## Ranson Road Subdivision Sketch Plan

### PART 1: PROJECT SUMMARY

Block Length for Cask Way (highlighted on image to the left) is 1,043 feet.

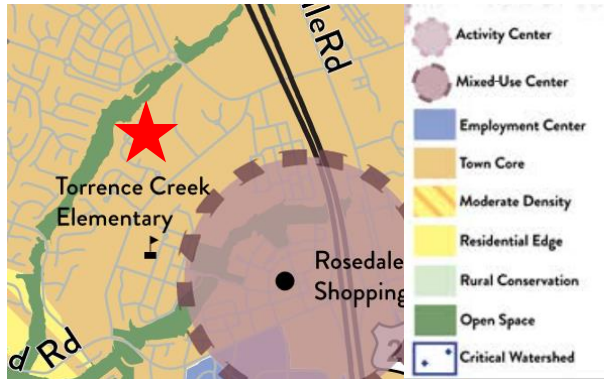
- **Block Length:** The applicant is requesting a block length modification per Article 5.2 which states major residential subdivision blocks are not to exceed 800 linear feet. This Article also allows the Town Board to authorize greater block lengths where a longer block will reduce the number of railroad grade crossings, major stream crossings; or, where longer blocks will result in an arrangement of street connections, lots and public space more consistent with Article 5 and Article 7.

Revised Design:

Original Design:

*Staff supports this modification request as the road design allows for additional open space on the eastside of the development and creates a better transition to the Timberview neighborhood.*
